## Product Change Notification / MFOL-18PVHH137

CCB 6694 Final Notice: Qualification of MTAI as a new final test site for selected ATMEGA128, ATMEGA16xx, ATMEGA32, ATMEGA48, ATMEGA64, ATMEGA8xx, ATTINY13, ATTINY24, ATTINY25, ATTINY44, ATTINY45, ATTINY84 and ATTINY85 device families available in various packages.

**PCN #: MFOL-18PVHH137**

# Pre and Post Summary – Pin 1 Orientation

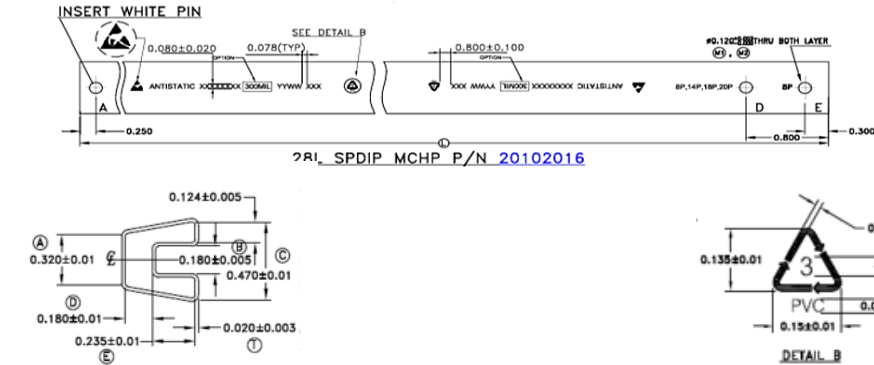
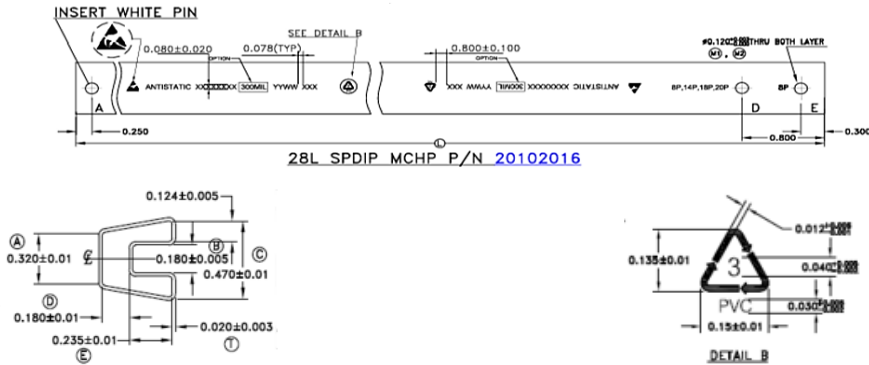
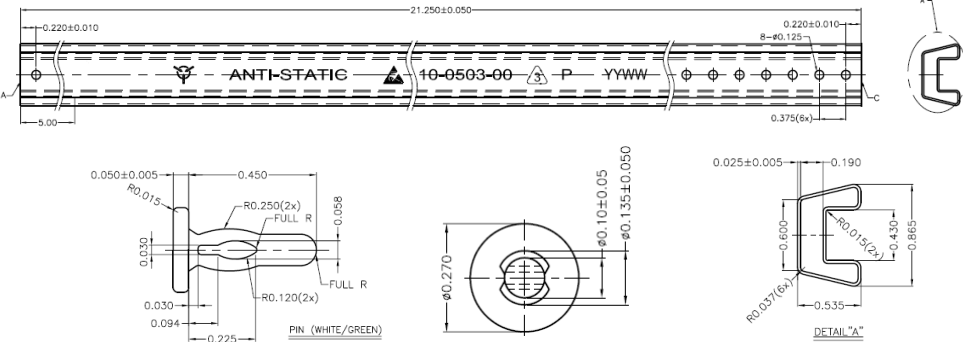
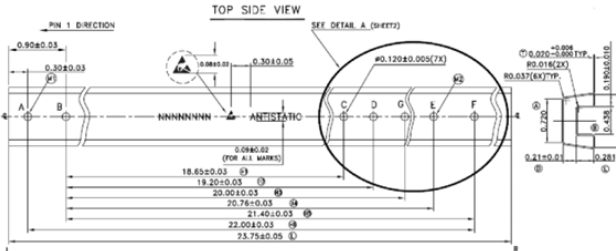
LPI	MTAI
Tube	8L PDIP	Pin# 1 Toward Green stopper or pin	Pin# 1 Toward White stopper or pin (Opposite Side: Black)
	14L PDIP		
	28L SPDIP		
	40L PDIP

# Pre and Post Summary – Antistatic Shielding Bag / Moisture Barrier Bag

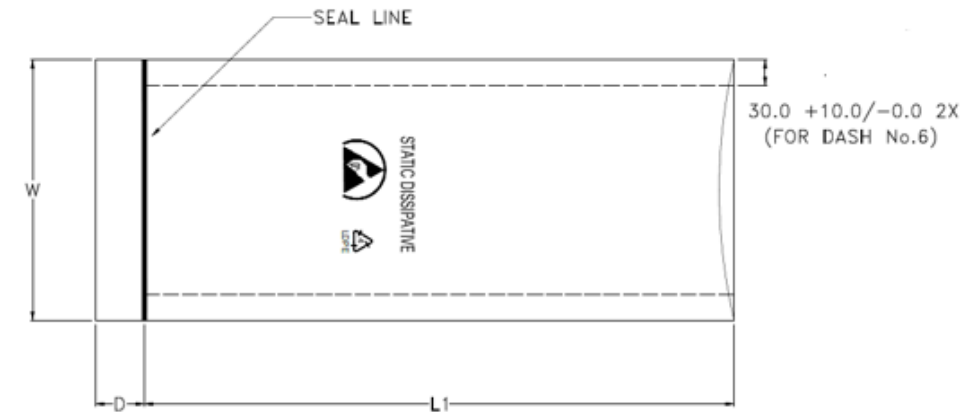
0.08mm\*21cm\*77cm

DASH NO.	W	L1	D(Min.)	BAG COLOR
- 1	305 ±6.0	752 ±13.0	8	PINK
- 2	152 ±4.0	752 ±13.0	8	PINK
- 3	318 ±6.0	473 ±8.0	8	PINK
- 4	711 ±12.0	777 ±13.0	8	PINK
- 5	356 ±6.0	375 ±6.0	5	TRANSPARENT
- 6	140 +10.0/-0	760 +10.0/-5	12	PINK (GUSSET TYPE)
- 7	80 ±5.0	120 ±5.0	12	PINK
- 8	228.6 ±6.35	304.8 ±9.525	12	PINK
- 9	260 ±5.0	370 ±6.0	7	PINK
- 10	914 ±15.0	787 ±13.0	10±2	PINK
